WINDSOR URBAN DEVELOPMENT CONTROL PANEL

28 February 2018

Application No.:	17/03636/FULL
Location:	Land To Rear of 54 To 60 Clewer Hill Road Windsor
Proposal:	Construction of 3 x 1 bedroom flats following demolition of garages 4 to 9 and stores
Applicant:	Mr Gray
Agent:	Mr Sean Kelly
Parish/Ward:	Windsor Unparished/Clewer East Ward

CM-PL-02	
PROPOSED ELEVATIONS	CLEWER MEWS
Rear of 54-56 Clewer Hill Road Windsor

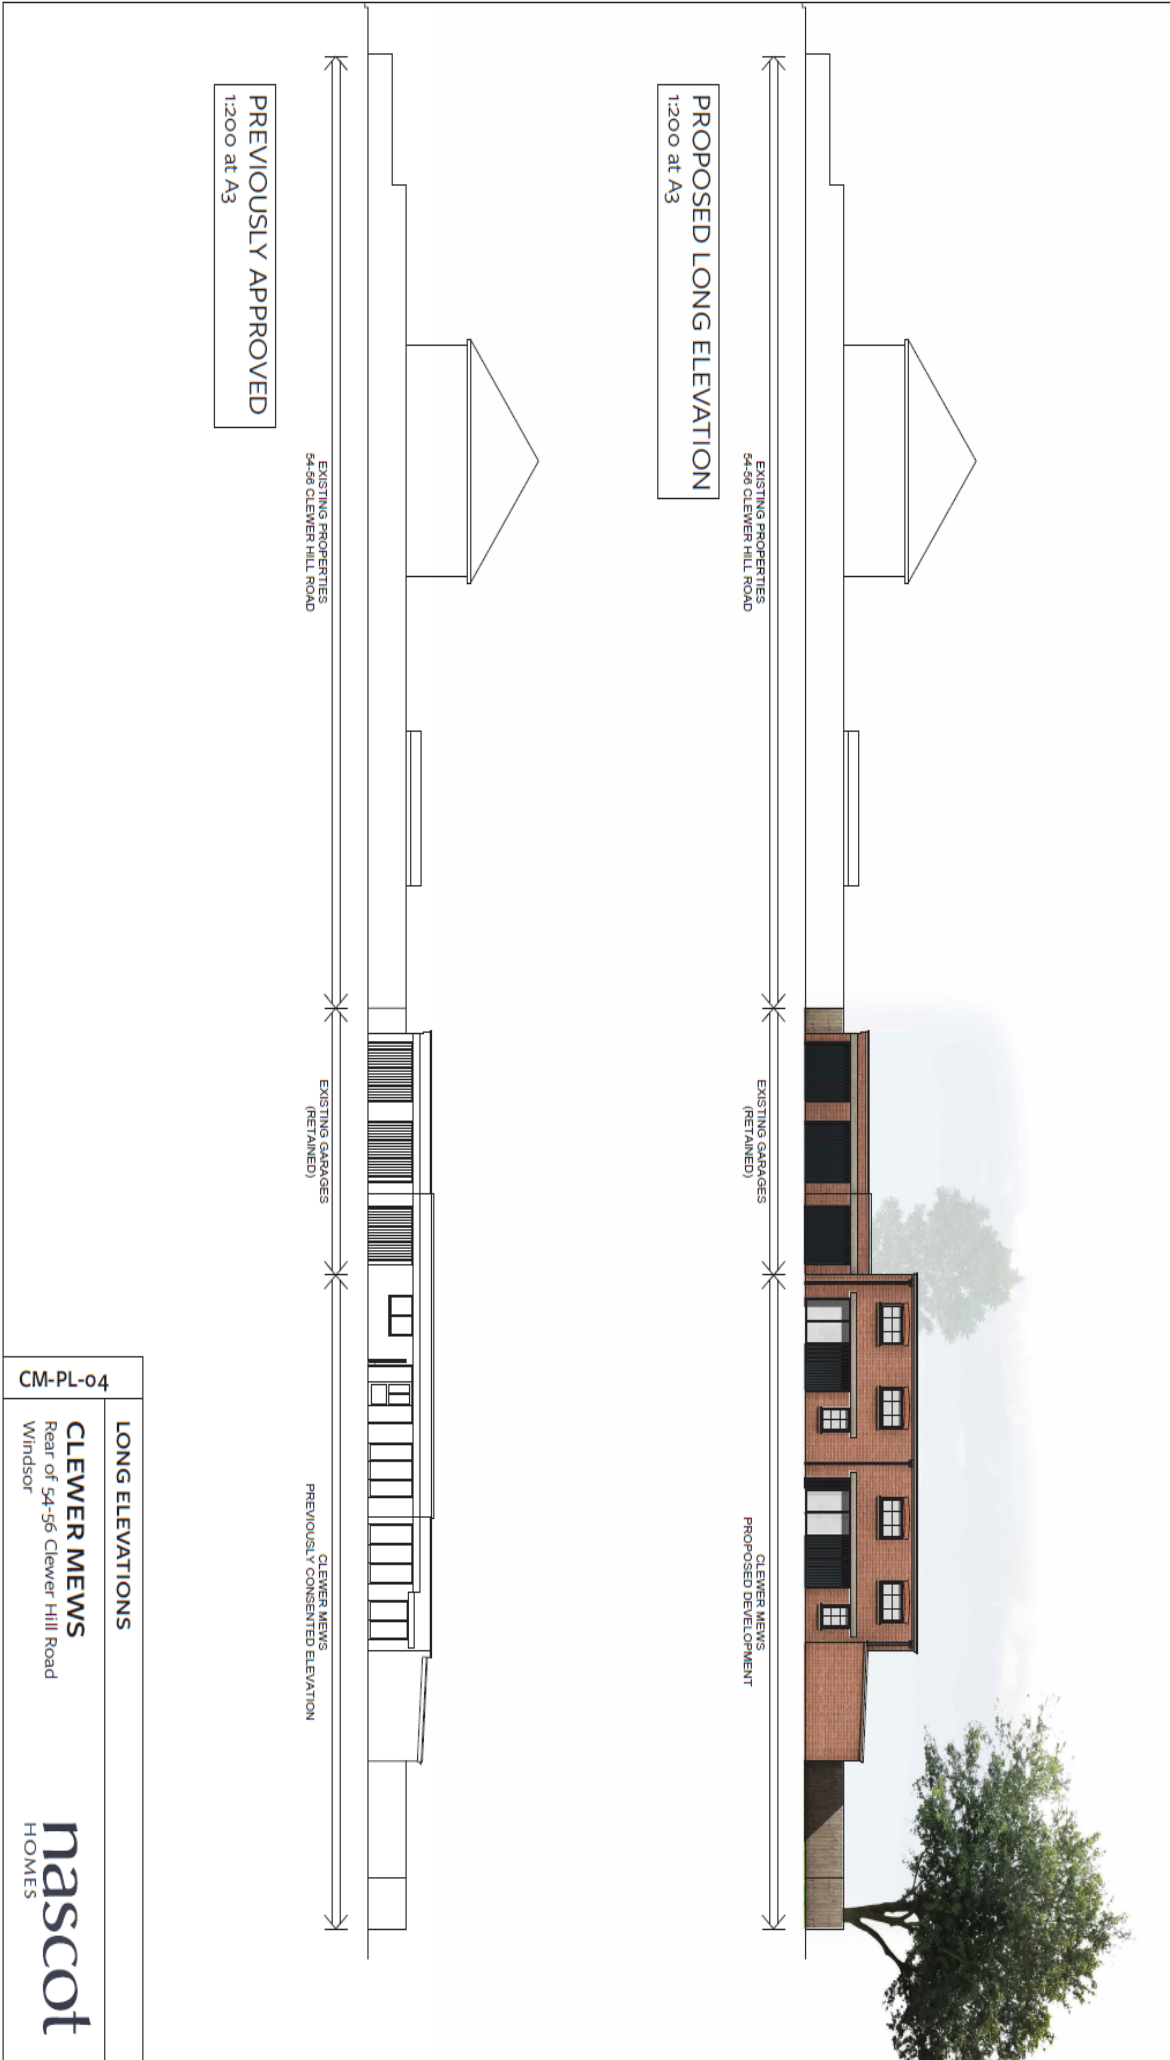
- 6.6 The proposed development has been designed in a mews style, courtyard development and the 2 storey buildings would have flat roofs with an overall height of 5.3m. This type of mews design is not a typology common to the area and the fact that the first floors have three blank sides' makes for poor design as well as being an indication of poor layout. It is considered that the proposal would appear at odds and out of keeping with the general character of the surrounding residential area and would detract from the visual amenity of the locality in general.

PARKING TRACKING
1:500 at A3

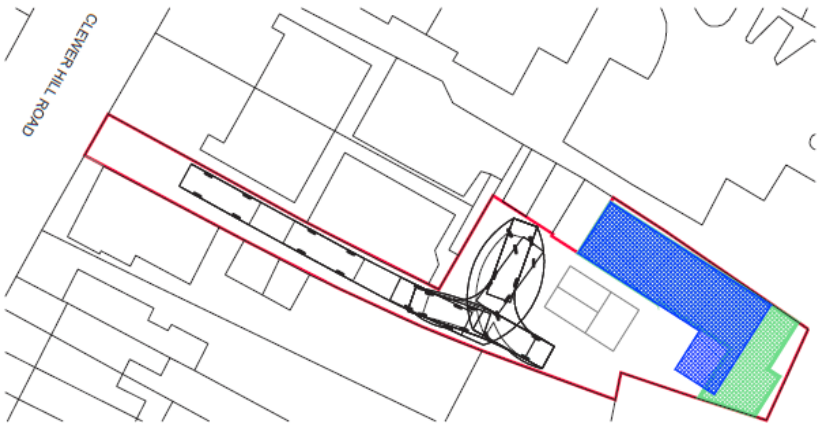
- 6.15 The application includes the provision of 3 parking spaces which complies with RBWM's current parking strategy. However the parking arrangement proposed is inadequate. A minimum clearance between the parking bays and restricted boundary should be 6m rather than the 5m shown to be provided. The proposed parking layout is therefore inadequate and needs to be reviewed.

- 6.16 The application includes one secure, covered cycle parking provision for each dwelling which complies with RBWM's current guidance.
- 6.17 Refuse storage is proposed perpendicular to the proposed parking bays. The proposed location of the refuse bins exceeds the maximum carrying distance from the highway. Therefore refuse access and turning for refuse vehicles must be accommodated within the site extent. Vehicle swept paths have been provided for a vehicle accessing the site, manoeuvring and exiting in forward gear. However details of the type and size of vehicle have not been provided. Refuse vehicle swept paths must be carried out, with vehicle details shown.
